STATE OF CONNECTICUT
CONNECTICUT SITING COUNCIL

IN RE:	:	
	:	
A PETITION OF CROWN CASTLE FOR A	:	PETITION NO. 1552
DECLARATORY RULING ON THE NEED TO	:	
OBTAIN A SITING COUNCIL CERTIFICATE	:	
FOR THE MODIFICATION OF AN EXISTING	:	
TELECOMMUNICATIONS FACILITY AT 845	:	
ETHAN ALLEN HIGHWAY, RIDGEFIELD,	:	
CONNECTICUT	:	FEBRUARY 15, 2023

**RESPONSES OF CROWN CASTLE TO
CONNECTICUT SITING COUNCIL INTERROGATORIES**

Figure 1: Graph of General Population % MPE vs. Distance

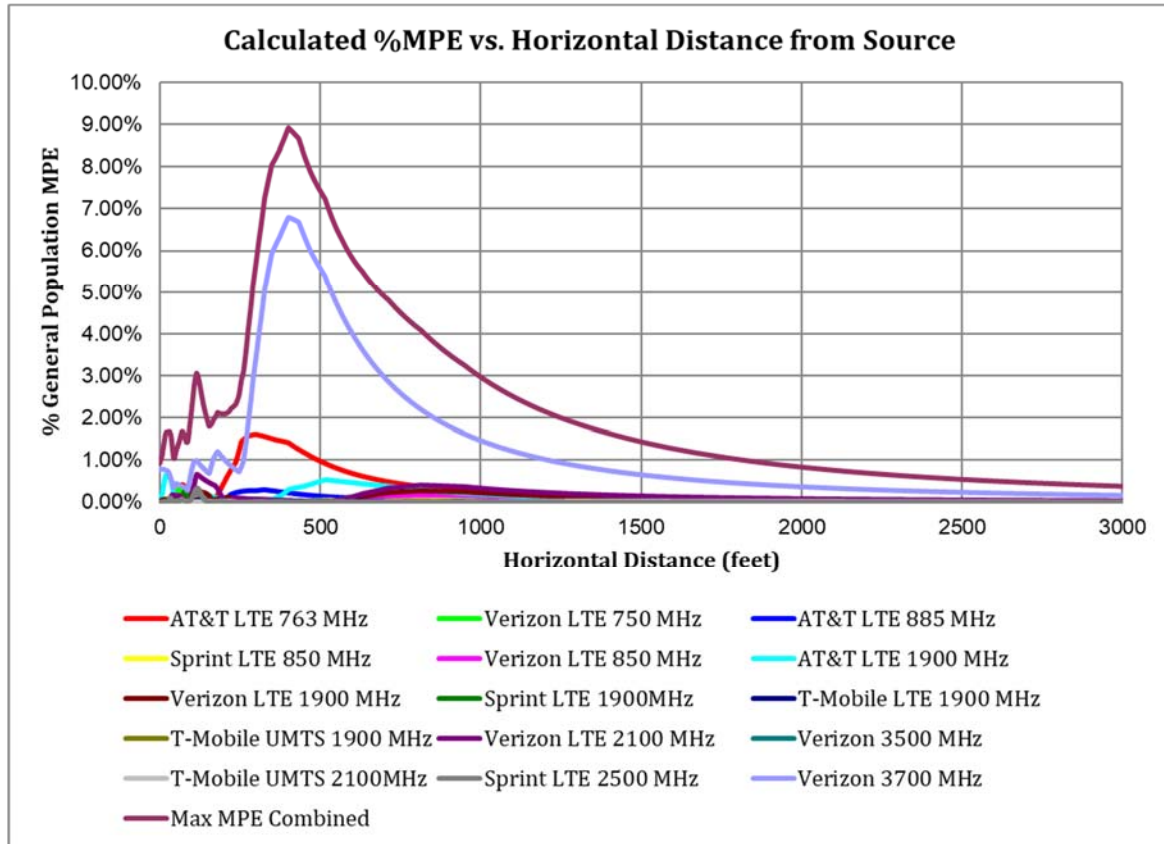
Provide a rigorous cumulative far-field radio frequency analysis for the facility that accounts for Celco's and all other entities equipment on the tower, accounting for a 6-foot tall person at ground level and the actual antenna patterns for the facility with a cumulative %MPE at or below 100%. Identify the distance from the tower with the highest cumulative %MPE.

The highest percent of MPE (8.92% of the General Population limit) is calculated to occur at a horizontal distance of 401 feet from antennas. Please note that the percent of MPE calculations close to the site take into account off beam loss, which is determined from the vertical pattern of the antennas used. Therefore, RF power density levels may increase as the distance from the site increases. At distances of approximately 1500 feet and beyond, one would now be in the main beam of the antenna pattern and off beam loss is no longer considered. Beyond this point, RF levels become calculated solely on distance from the site and the percent of MPE decreases significantly as distance from the site increases.

Table 2 below lists percent of MPE values as well as the associated parameters that were included in the calculations. The highest percent of MPE value was calculated to occur at a horizontal distance of 401 feet from the site (reference Figure 1).
